# Amendment Notice # 2

**Licence Number** L8912/2015/1

**Premises** Lamboo Gold Project  
M80/343, M80/355, M80/359, M80/362, M80/503,  
M80/471, L80/70 and L80/71  
MUELLER RANGES WA 6770

**Date of Amendment** 31 January 2018

Figure 2: Layout of proposed landfill area (green)

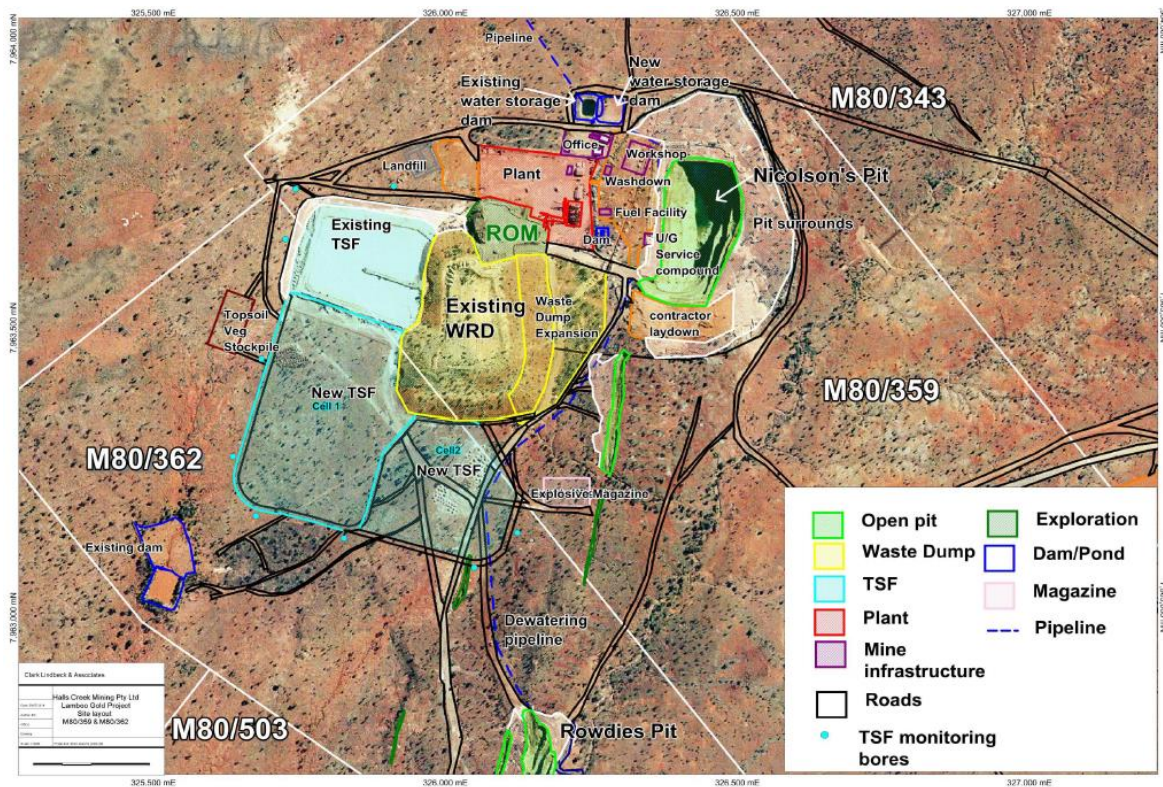
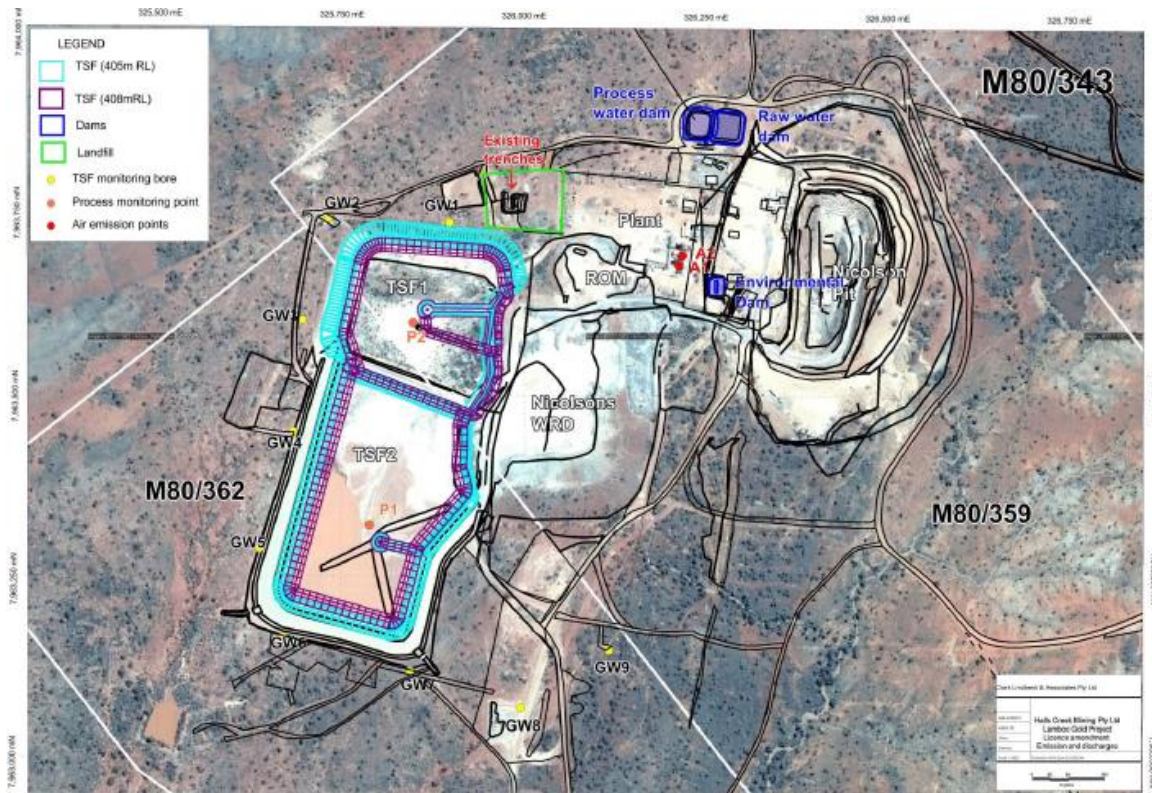
The current location of Lamboo's landfill as set out in the Licence is shown in Figure 1. The Licence Holder has constructed and is operating additional landfill trenches (of which they have not sought approval) adjacent to the approved landfill area. The Licence Holder has stipulated that this decision was based on a review of the site's mining proposal rather than the Licence and as a result an amendment to the Licence was not sought. The Licence Holder has since updated site procedures to ensure that any work undertaken in future is in accordance with the requirements of the Licence.

The Licence Holder wishes to expand the approved landfill area to include the entire fenced area surrounding the new trenches (0.9ha in total). This will allow the Licence Holder to construct future trenches within this area. The location of the new trenches and surrounding fenced area is shown in Figure 2.

The Licence Holder has committed to constructing future landfill trenches within the new designated landfill area only. This requirement has been formalised in Licence condition 1.2.2.

- This Licence has been amended by the insertion of the following Schedule 1: Maps Figure 2

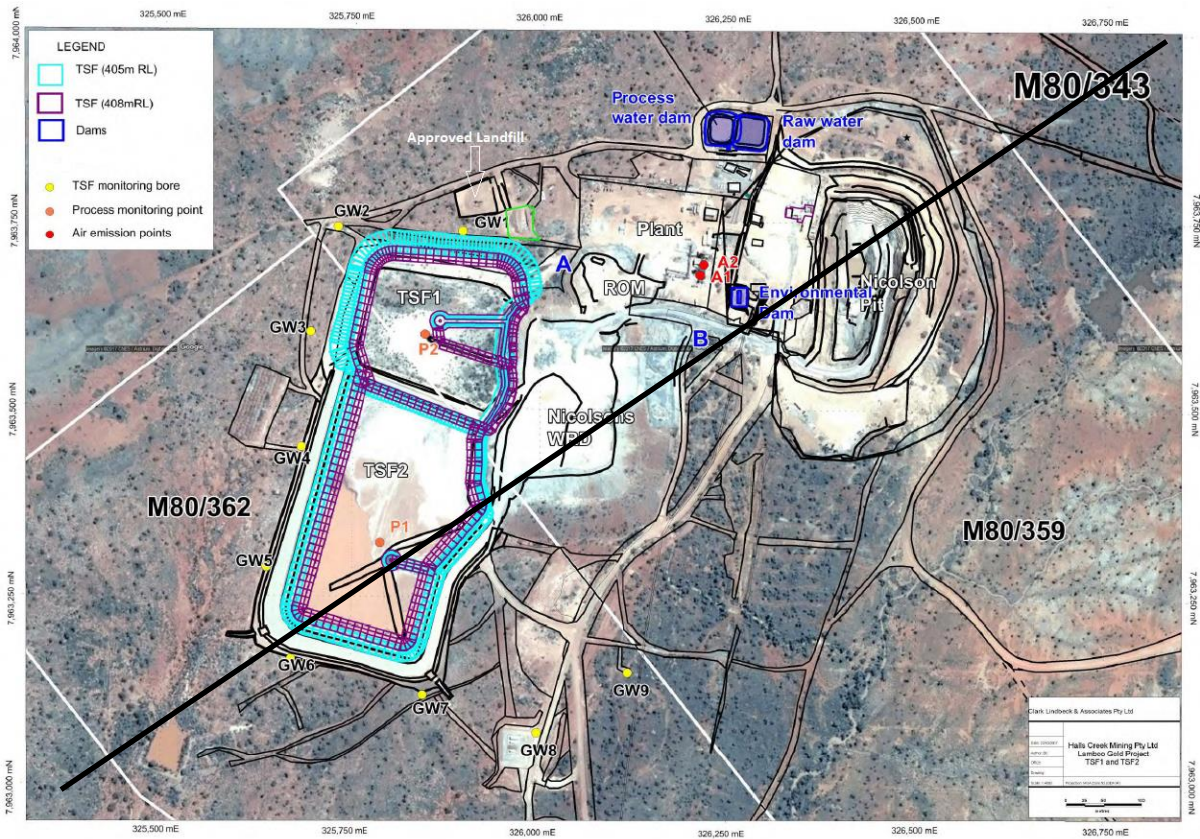
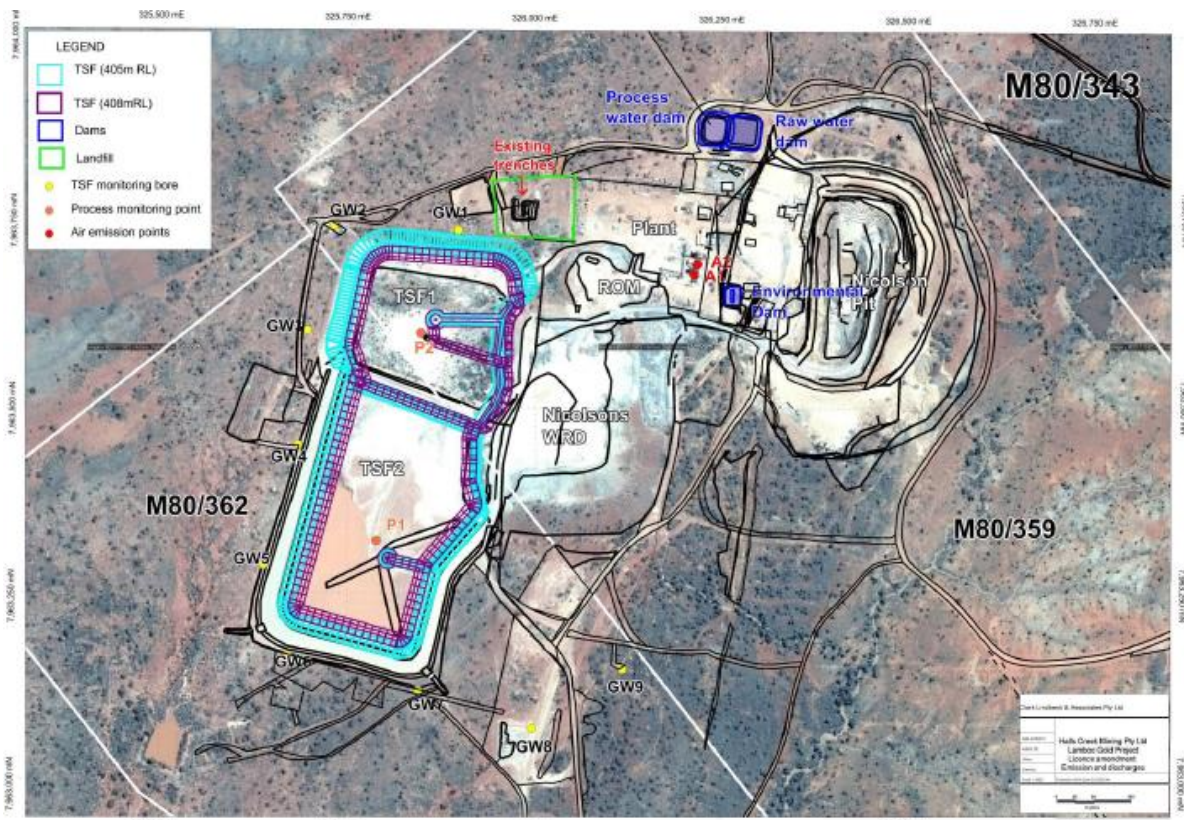
The Delegated Officer has also updated Figure 2 in Schedule 1 with a new map outlining the location of the new approved landfill area.

- This Licence is amended by the deletion of the following Schedule 1: Maps Figure 2 as shown in strikethrough.
